**Re: RESPONSE TO PLANNING PANEL MEETING COMMENTS – DA/2020/0815
No. 120C OLD CANTERBURY ROAD SUMMER HILL**

This letter responds to the Sydney Eastern City Planning Panel's (JRPP) comments dated 1 April 2021, and the reasons for deferral of the lodged development application DA/2020/0815, at No. 120C Old Canterbury Road Summer Hill.

The deferred proposal comprises *the construction of an 8-storey mixed-use development comprising ground level retail, 57 residential units, three levels of basement car parking and a pocket park.*

Figure 1: Excerpt Level 1 Floor Plan illustrating apartments subject to the PMF deleted and replaced with individual storage units

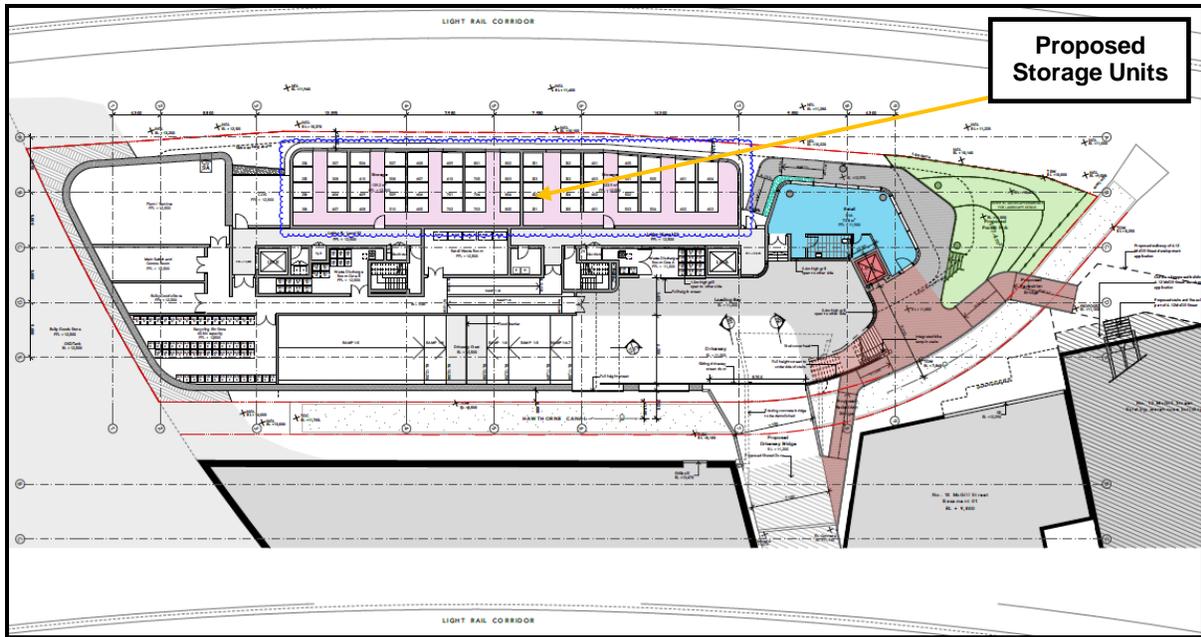
2. Deletion of any residential floor space that is subject to the Probable Maximum Flood level (PMF).

As described in amended architectural plans accompanying this letter, and in response to the panel's comments, the proposal has been modified for the three (3) originally proposed units subject to the Probable Maximum Flood level within Level 1 to be deleted.

The amended design proposes to incorporate individual storage space for units within Level 1 (**Figure 1**). Furthermore, given the deleted proposed units to Level 1, the amended design proposes to delete the refuge room from Level 2, and replaced with Mail Rooms (**Figure 2**). In this regard, the GFA/ FSR is proposed to remain as originally proposed.

Figure 3: Excerpt Level 6 Floor Plan illustrating refuge increased building separation to No. 14 McGill Street.

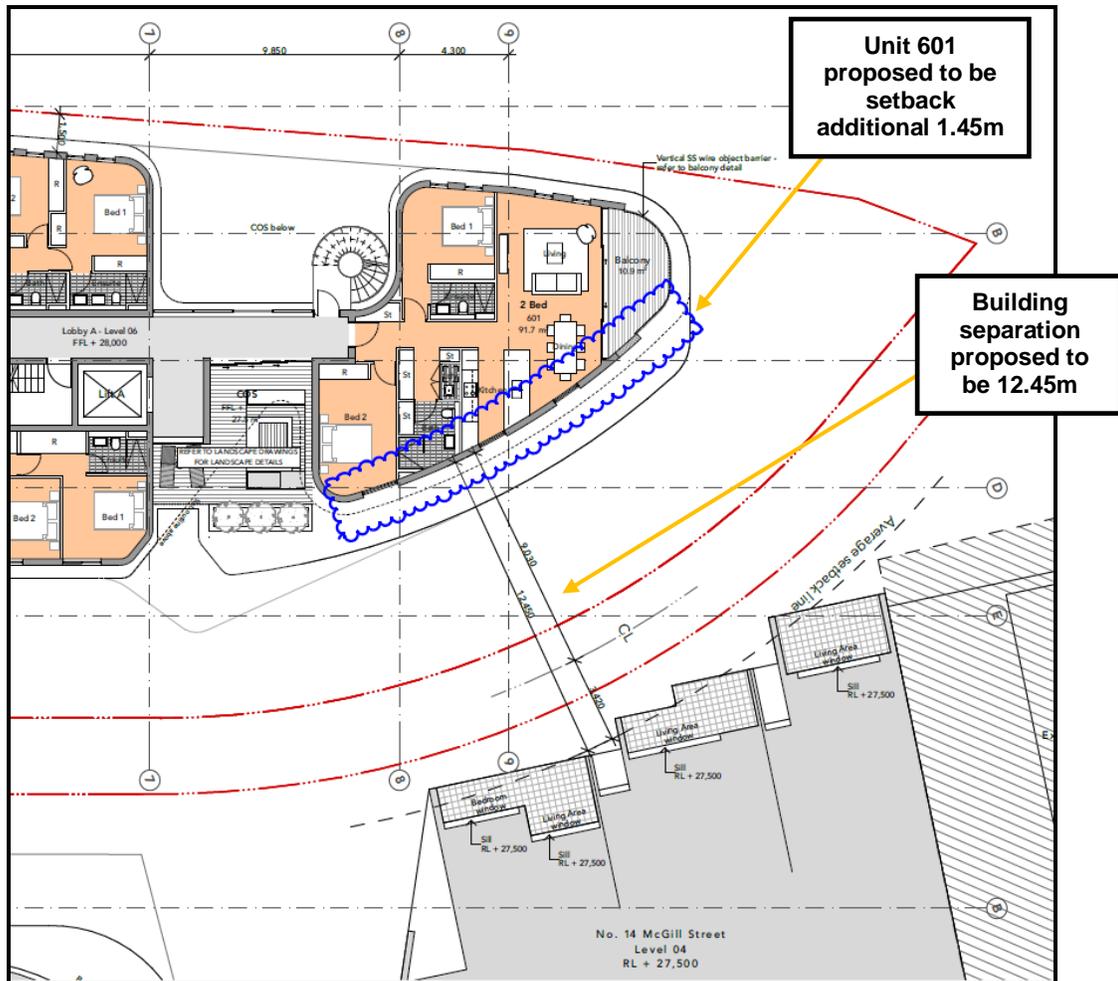
- 3. Increase the setback to the Eastern boundary to the centre of Hawthorn Canal from 7.5m to 9m.

As described in amended architectural plans accompanying this letter, the proposed unit on Level 6 being is proposed with an additional setback of 1.45m, to provide a 12.45m building separation in accordance with the Apartment Design Guide (ADG) to No. 14 McGill Street (**Figure 3**).

Figure 7: Excerpt Hood Perspectives Plan illustrating amended privacy treatment

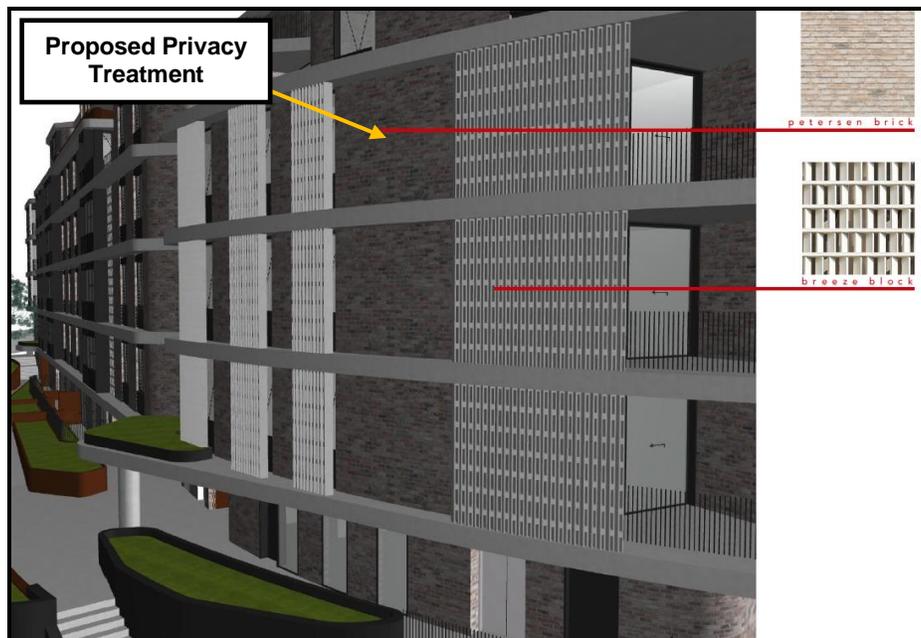
- 4. Delete external privacy blades and replace with alternative design privacy measures.

As described in amended architectural plans accompanying this letter, and in response to the panel’s comments, the proposal has been modified to provide an alternative ‘breezeblock’ screen privacy treatment to windows to retain amenity to adjoining neighbours to the east (Figures 7, 8 & 9).
